142. Physical Coding Sublayer and Physical Media Attachment for Nx25G-EPON

To the Editor: new text and SD figure for 142.3.5.6 PCS BER monitor process. Includes one "shall" for the PICS. Suggest moving this subclause immediately after 142.3.5.7 PCS Output Process for better description flow.

142.3.5.6 PCS ONU BER monitor Process

Figure 142-X—LDPC BER monitor state diagram (ONU only)

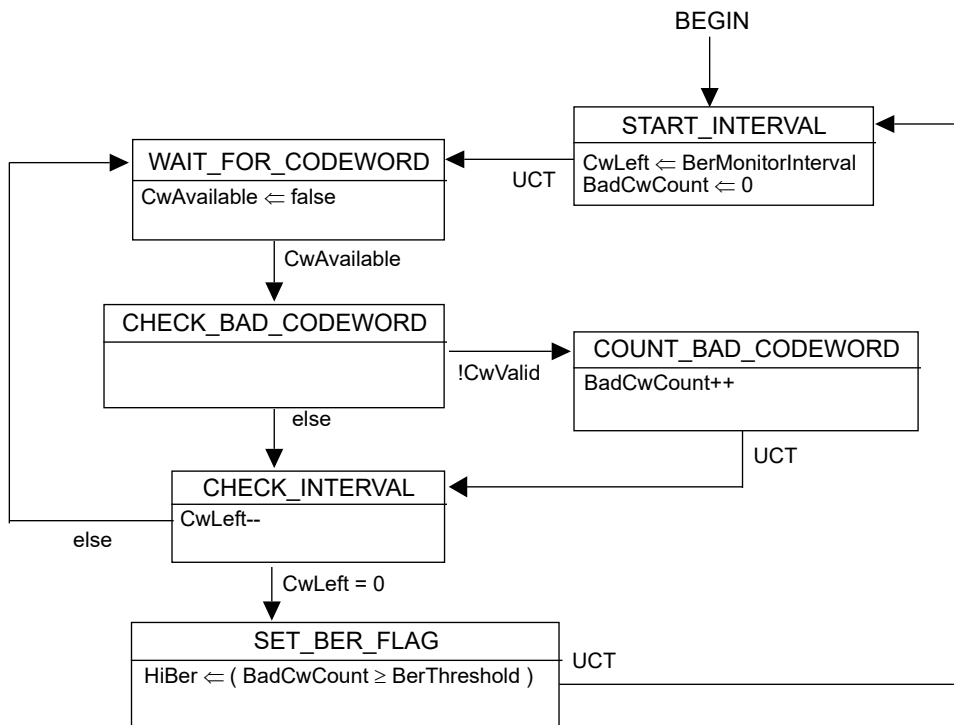
When the ONU Synchronizer Process has obtained block synchronization, the LDPC BER Monitor Process monitors the signal quality asserting *HiBer* if a count of LDPC parity errors reaches *BerThreshold* within the timer interval. The ONU PCS shall perform the operation of the LDPC BER monitor shown in Figure 142-X.
